### **3.10 Noise and Air Resources Comments and Responses**

#### **NOISE RESOURCES**

**Figure 3.10-1: Noise Monitoring Locations and Sensitive Receptor Locations Buena Vista Teutonia PUR City of Yonkers, Westchester County, NY**  
Base Map: Westchester County GIS  
Scale: 1" = 400'

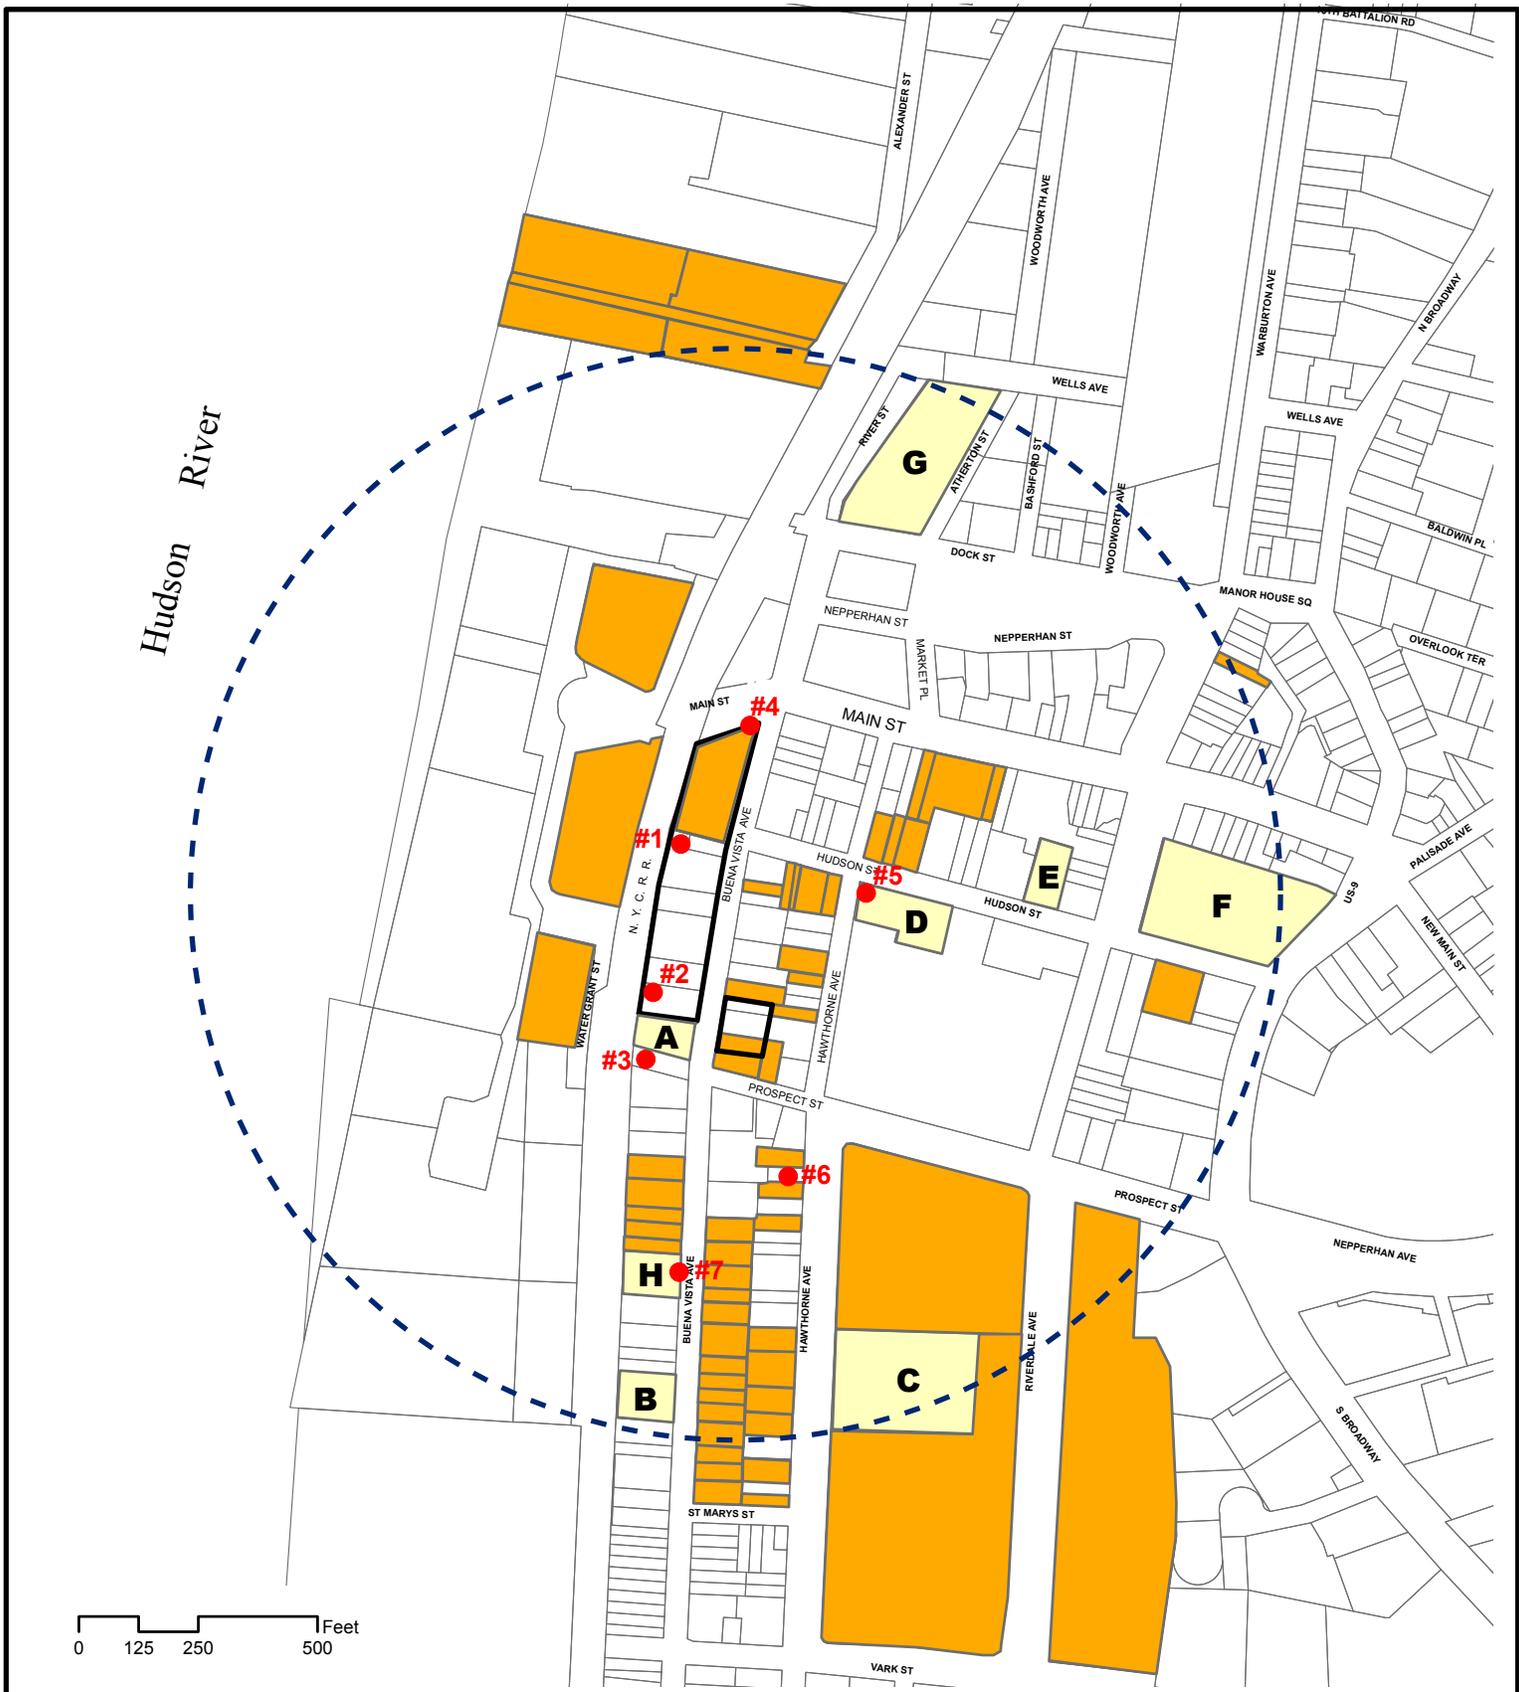
**Comment 3.10-4 (Letter 17, January 21, 2011, David McInerney, AICP, PS&S - City Engineering Consultant):** Page 3.10-7: Sensitive Receptors and Table 3.10-5 (Sensitive Receptors within 1,000 feet of the Project Site) - The DEIS identifies noise receptor sites in the vicinity of the project area, but does not identify the location of residential receptors. Residential receptors should be identified.

Figure 3.10-1 the radius for the 1000-foot circle was drawn from the center of the site instead of edges. Would any other sensitive receptors be hit if the area was taken from each edge? Why were the recreation pier and the Hudson River promenade not included as sensitive receptors?

**Response 3.10-4:** *The DEIS describes "sensitive receptors" (page 3.10-7 of the document), and they include "residences, schools, daycare facilities, hospitals, churches, cemeteries, libraries, nature preserves and certain types of outdoor recreation areas". Table 3.10-1 (Revised DEIS Table 3.10-5) identifies specific sensitive receptors within 1000 feet of the property, but does not include specific residences. Table 3.10-1 (Revised DEIS Table 3.10-5) below includes a note stating that "residential receptors within 1000 feet of the property are identified on revised Figure 3.10-1. That DEIS Figure 3.10-1 has been modified to include all residential sensitive receptors, and is provided at the end of this FEIS section.*

Source: Tim Miller Associates, Inc. 2010.  
Note: Residential receptors within 1000 feet of the project site are shown in revised Figure 3.10-1, provided at the end of this FEIS Section.

*There are a number of residential properties within 300 feet of the project site that would likely be affected by construction noise. These residential locations are shown in Figure 3.10-1.*

***Response 3.10-22:*** *The project site is relatively small and therefore, a 1000 foot radius circle was provided from the center of the site, instead of from the property boundaries. If the circle was expanded from the site boundaries, additional residences would be captured in the 1000 foot radius. No additional churches, parks, hospitals, libraries or institutional sensitive receptors would be added.*

*The recreation pier and the Hudson River Promenade are now included on revised Figure 3.10-1.*

**Figure 3.10-2: Temporary Noise Barrier**  
 Buena Vista Teutonia PUR  
 City of Yonkers, Westchester County, New York  
 Base: The Lessard Architectural Group, P.C.  
 BKSK Architects, LLP  
 Drawing Date: 10/09/10

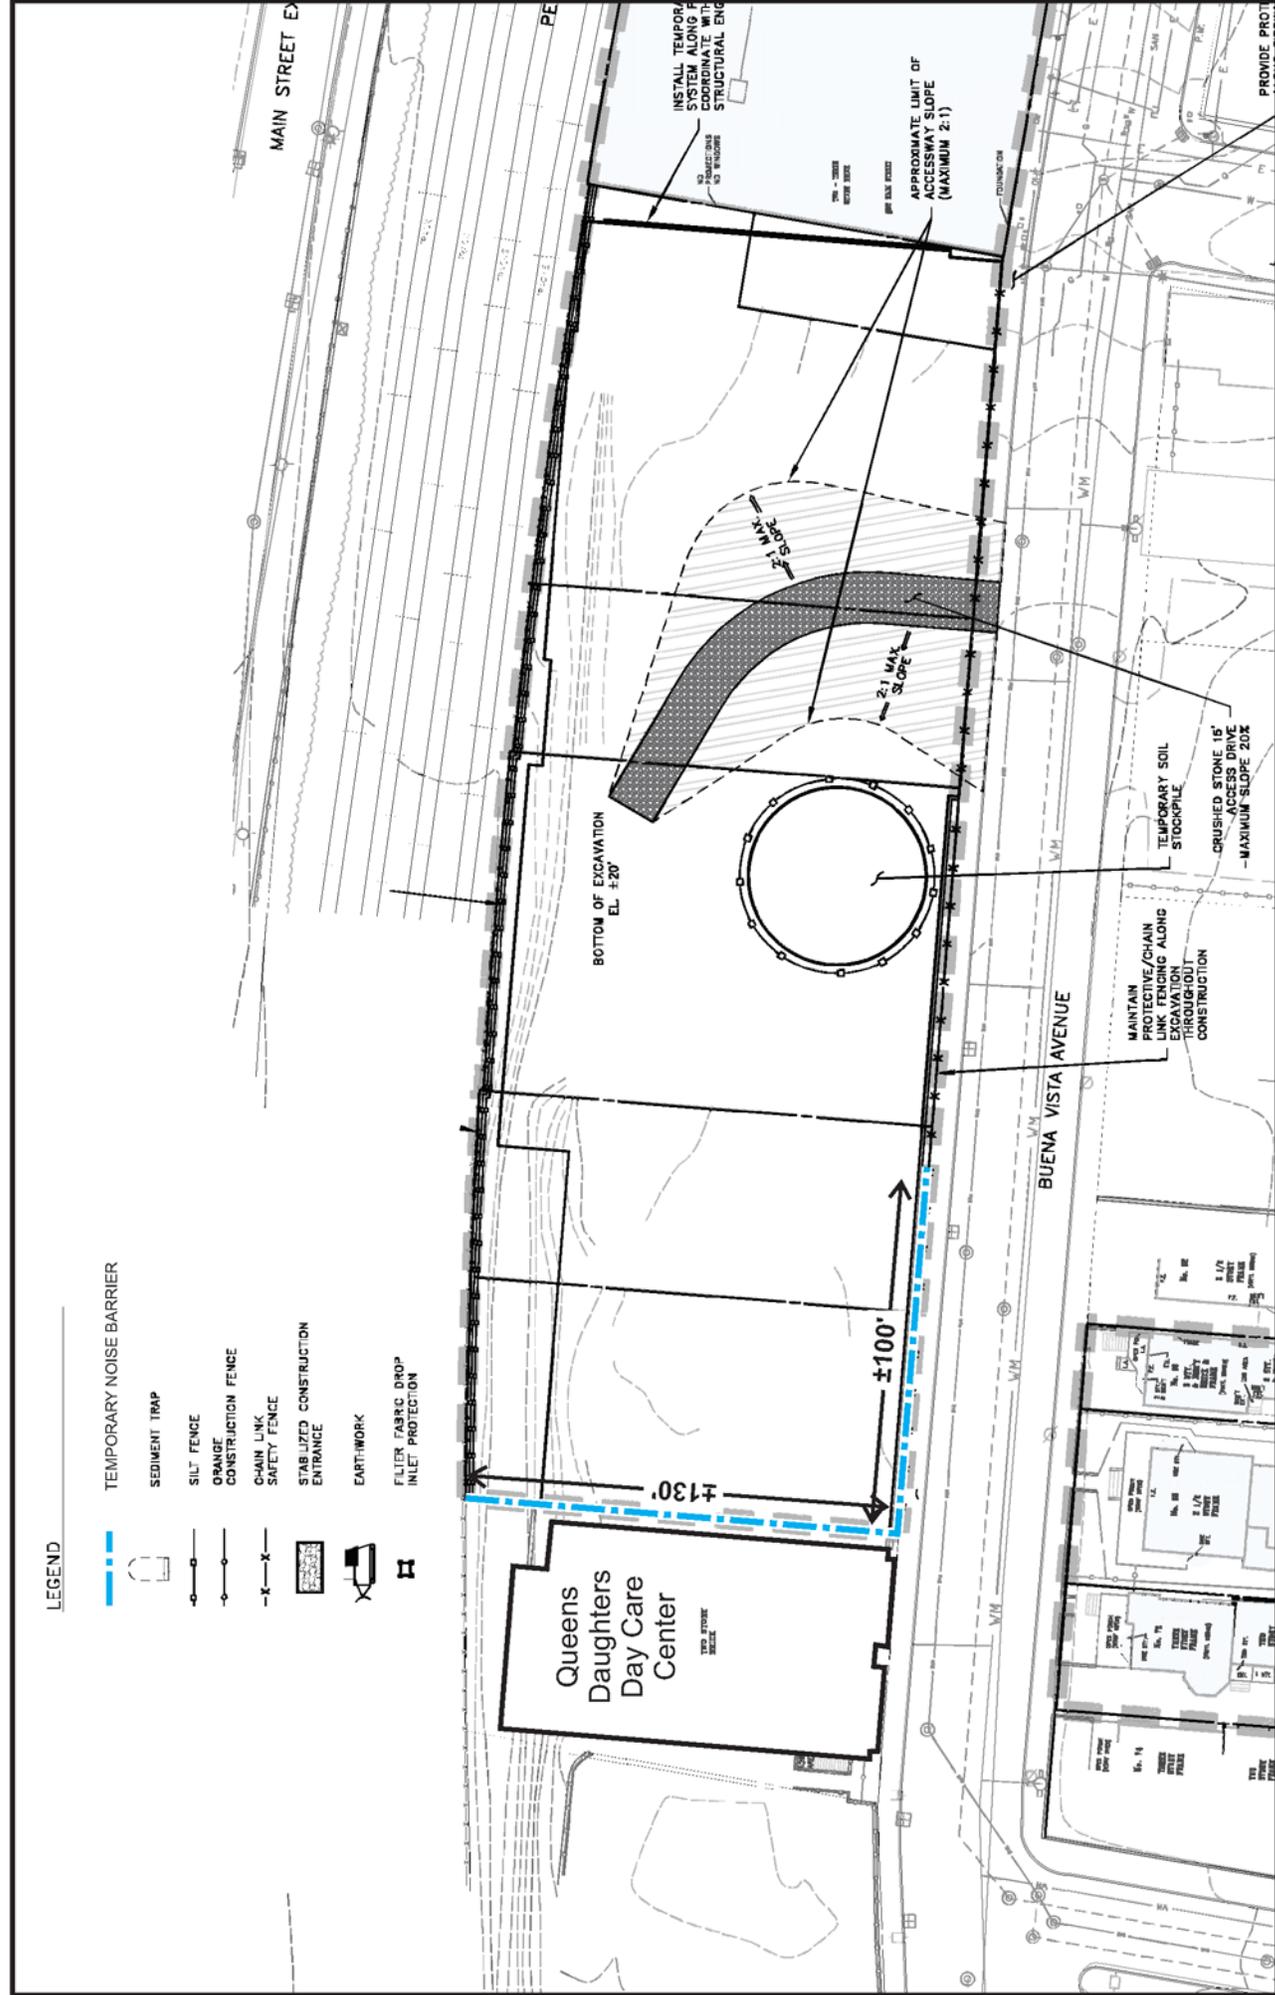
**Comment 3.10-16 (Letter 17, January 21, 2011, David McInerney, AICP, PS&S - City Engineering Consultant):** Page 3.10-11: Construction Mitigation – “The construction manager will notify the Queen’s Daughter’s Daycare Center regarding activities that are expected to produce high noise levels. If necessary the use of a temporary noise barrier may reduce the impacts related to construction to the Queen’s Daughter’s Daycare Center.” The DEIS Section 3.10.1.3 Mitigation Measures includes a discussion of potential noise mitigation. However, this section does not identify or describe mitigation measures in sufficient detail.

3.10-9 Construction impacts at Queens Daughter daycare to reach 85 dBAs. What can be done to mitigate noise impacts?

*The applicant proposes to erect a temporary construction noise barrier along the southern property line, shared with the Queen’s Daughter daycare, and along a portion of Buena Vista Avenue. The noise barrier will have a Sound Transmission Class (STC) rating of at least 30. According to a noise barrier supplier, Controlled Acoustics, sound levels opposite the noise barrier will be reduced by approximately 10 to 15 dBA (to approximately 77 to 82 dBA), since a certain amount of noise will pass over the wall as noise “shadow”. The Queen’s Daughter Daycare playground is located south of the daycare building, and therefore the building will provide an additional solid barrier between the playground and the construction activity. Given the height of the daycare building, at approximately 24 feet, the building will reduce the construction noise reaching the playground by an additional approximately 12 dBA<sup>3</sup>. Outdoor noise from*

*Given the potential for noise impacts to the daycare, the applicant will provide a temporary noise barrier along the southern property line. The noise barrier will be approximately 170 feet in length and will span the entire southern property line and extend approximately 50 feet from the southern property corner along Buena Vista Avenue (see Figure 3.10-2). It is estimated that the barrier will be approximately 22 feet in height to block the line of sight from the second story windows in the daycare building although this will be determined during detailed site plan review. The specifications for the noise barrier will be subject to engineering design and City of Yonkers Building Department review. The barrier will be constructed of plywood covered with noise absorptive material, such as SoundSeal model BBC-13-2, or equivalent. This material is specified for construction projects in Chapter 28 of the New York City Noise Code.*

*According to the noise barrier supplier, the material will typically reduce noise by 10 to 15 dBA<sup>7</sup>.*
